FOUNDATION INVESTIGATION REPORT BY:
Gordon, Limited, Consulting Engineers -
Proposed Highway 7 and 15 Underpass,
District 3 (Ottawa) - M.F. 905-64 -

Re: Soil Conditions and Foundations,
Proposed C.N.R. Grade Separation,
Highway 15 and 7,
Ottawa, Ontario.

W.P. 908-64 --
Hwy. #7 and #15,
C.N.R. Underpass,
District #9 (Ottawa).

Re: Hwy. 7 and 15, W.P. 908-64
C.N.R. Underpass - Ottawa

SCALE: 1" = 50'

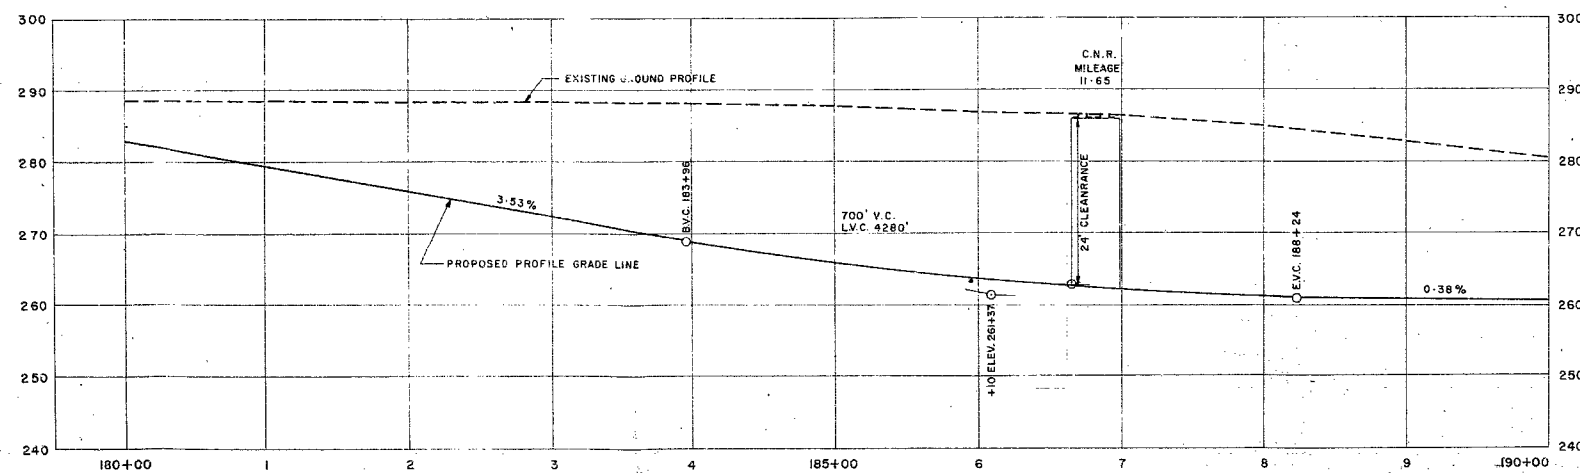
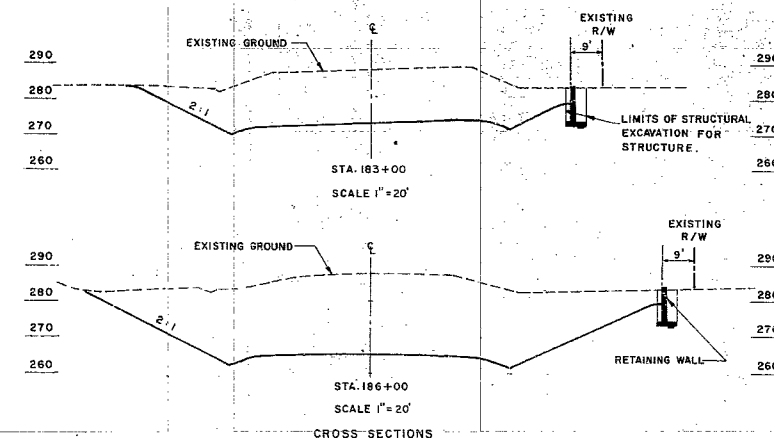
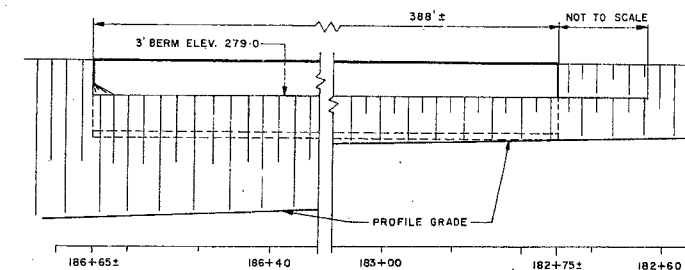
Attached please find a plan indicating the general layout of the proposed highway detour and typical cross-sections of the proposed roadway excavation using 2:1 cut slopes. We have plotted the typical cross-sections on actual original groundline cross-sections, using 3:1 cut slopes as recommended in the foundation report and also the present proposal for the highway detour.

Please advise whether the detour is stable in this proposed location and if not what is the minimum safe distance between the detour centreline and the top of the cut slope.

Following your memo of January 12, 1967, we have reviewed the Foundation Report with regard to the feasibility of constructing the 4-ft. high detour immediately adjacent to a proposed 3:1 cut slope. Based on the stability analyses already carried out, it appears that this small height of fill will have very little effect on the overall stability.
